Memorandum

Planning and Urban Development Department

Date: July 7th, 2017

Re: **July 11th 2017 Planning Board Workshop**
Level III Site Plan, Subdivision and Inclusionary Housing:
12 unit Condominium, One Joy Place
Onejoy Place, LLC , Applicant

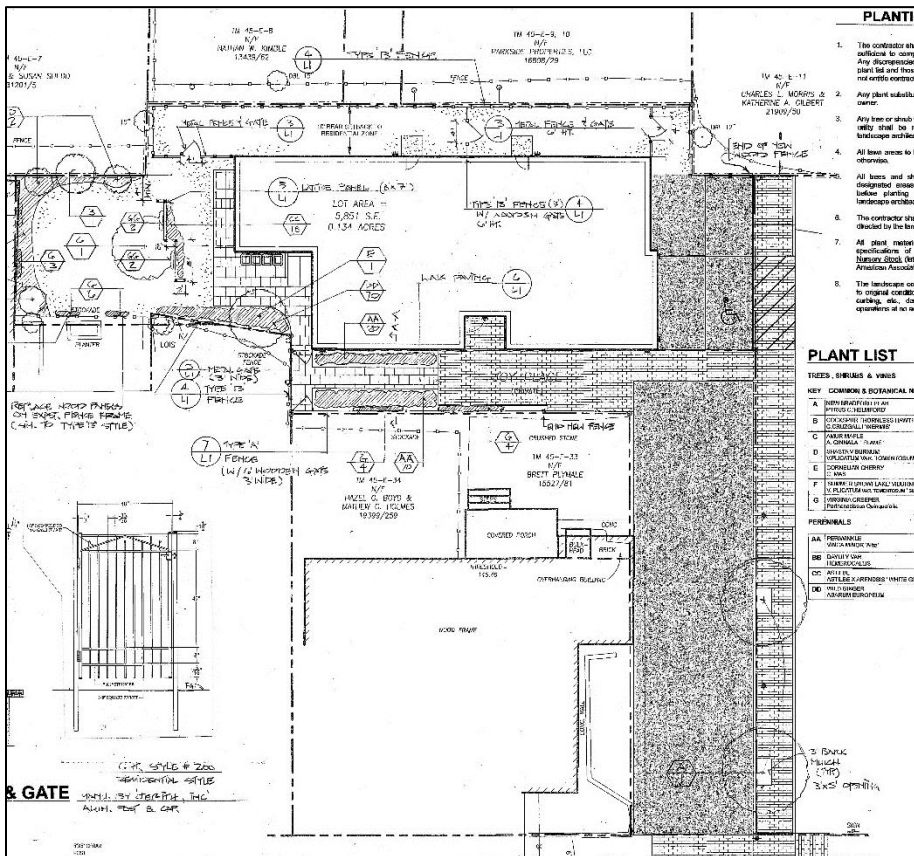
Two of the first-floor units have private yard areas at the back, and a community open landscaped area is provided for all residents to the north of the building (see Landscaping Plan below & in Plan P11)

Landscaping: The proposed brick sidewalk with trees appears to be located on City of Portland land and the applicant will need to provide a license or other agreement that gives him rights to carry out this work. This amenity could be located within Joy Place if the pedestrian paved area was flush. Revisions to the proposals for the area within the narrow part of Joy Place are anticipated in order to address the neighbor concerns (167 Brackett- see PC1) and any comments from the City Arborist.

Street Trees: The project needs to include 12 street trees (one per unit) and has proposed two street trees in Joy Place to demarcate the pedestrian walkway. A revised plan is required to show the final location of the trees that takes account of the emergency service access requirements and parking provision for the existing units adjacent to Joy Place. In addition, the applicant is requested to confirm how the remaining 10 required street trees will be provided (noting the options available in the Technical Standards).
